Location of Construction: 540 Forest Avenue		Owner: Searly In Business		Phone: 772-5263		Permit No: <b>980409</b>	
Owner Address: Searly In Business, Inc.		Lessee/Buyer's Name: The Great Lost Bear		Phone:		BusinessName:	
Contractor Name: Gary Shank		Address: 15 Oak St., So. Portland, ME		Phone: 767-2934		Permit Issued: <b>PERMIT ISSUED</b> APR 27 1998	
Past Use: commercial		Proposed Use: commercial		COST OF WORK: \$ 4,000			
Proposed Project Description: replacing existing patio with deck		FIRE DEPT. <input type="checkbox"/> Approved <input type="checkbox"/> Denied Signature: <i>[Signature]</i>		INSPECTION: Use Group <u>A-3</u> Type <u>53</u> Signature: <i>[Signature]</i>		Zone: <u>126 B005</u> CBL:	
				PEDESTRIAN ACTIVITIES DISTRICT (P.A.D.) Action: <input type="checkbox"/> Approved <input type="checkbox"/> Approved with Conditions <input type="checkbox"/> Denied Signature: _____ Date: _____		Zoning Approval: <b>Special Zone or Reviews:</b> <input type="checkbox"/> Shoreland <input type="checkbox"/> Wetland <input type="checkbox"/> Flood Zone <input type="checkbox"/> Subdivision <input type="checkbox"/> Site Plan maj <input type="checkbox"/> minor <input type="checkbox"/> mm <inp

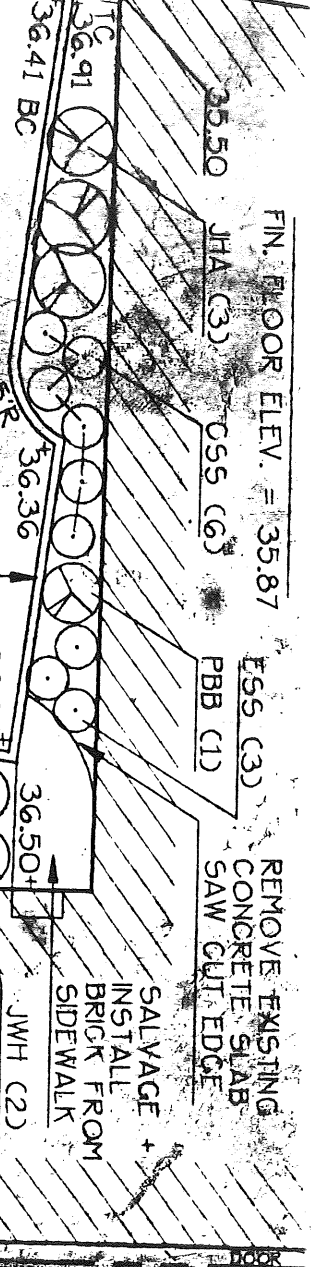
*Handwritten:* 101 rear setback No side setback Reg.

*Handwritten:* GREAT LOST BEAR \* Yellow = Proposed Deck
